City of Steamboat Springs Development Review Team (DRT) Comment Response for:

The Amble – Development Plan Application

Planning Review – Reviewed by Toby Stauffer, AICP

SK-1 Planning DRT Question 2, from page A1.00

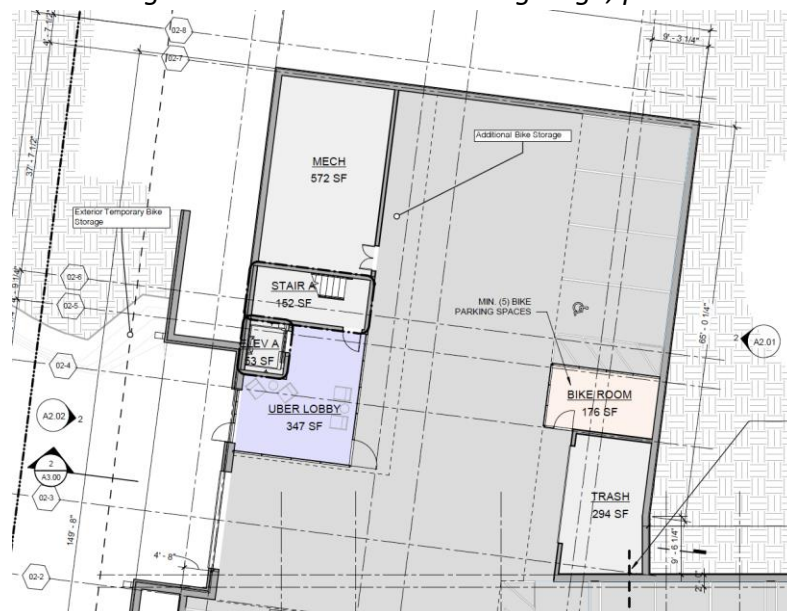
1. **As the subdivision changes ensure that the current proposed lot layout is shown on plans for this project. Consider a simplified lot line for the property line adjacent to the Grand to allow space for maintenance and egress to the Grand.**
 - **Response:** *Please refer to the Preliminary Plat Application (PL20220479).*
2. **406.C.7: How much bike parking will be provided in the bike storage area? a minimum of 4 bike parking spaces is required.**
 - **Response:** *Please refer to the updated project narrative as well as G0.00 and A1.00. A minimum of (5) bicycle parking spaces will be provided per CDC Section 406.C.7 and Table 406-4. Further bike spaces will be on racks within the garage and on a few racks outside of the ground level waiting area.*
 - *Bike Storage will be located inside the garage, per Sk-1 below.*

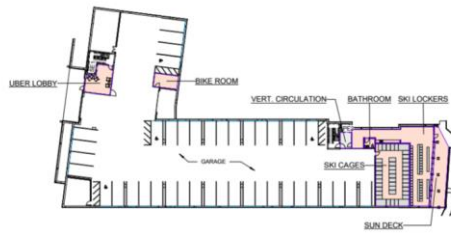
9. L4 and G0: update total to be accurate, should also be consistent with cover page.

- **Response:** G0.00 has been updated to refer to the landscape drawings for snow storage requirements and conformance. Please see sheet L4.00 for Snow Storage Plan and Tables showing requirements and conformance.

Garage Level Amenity Plan

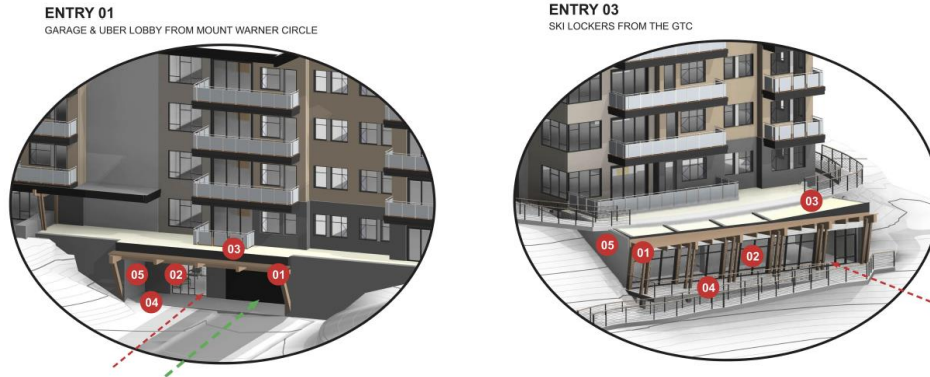
11. CDC Sec. 440.C.1.b: It looks like the project is providing the required amenities, however, provide calculations of amenity spaces to demonstrate the project meets this standard. Indicate which amenity spaces are included in the calculations through a diagram.

- **Response:** The overall net amenity area is 18.9%. Please use Drawing Sheet G1.00 for the area breakdown. Excerpts from G1.00 Can be found below.
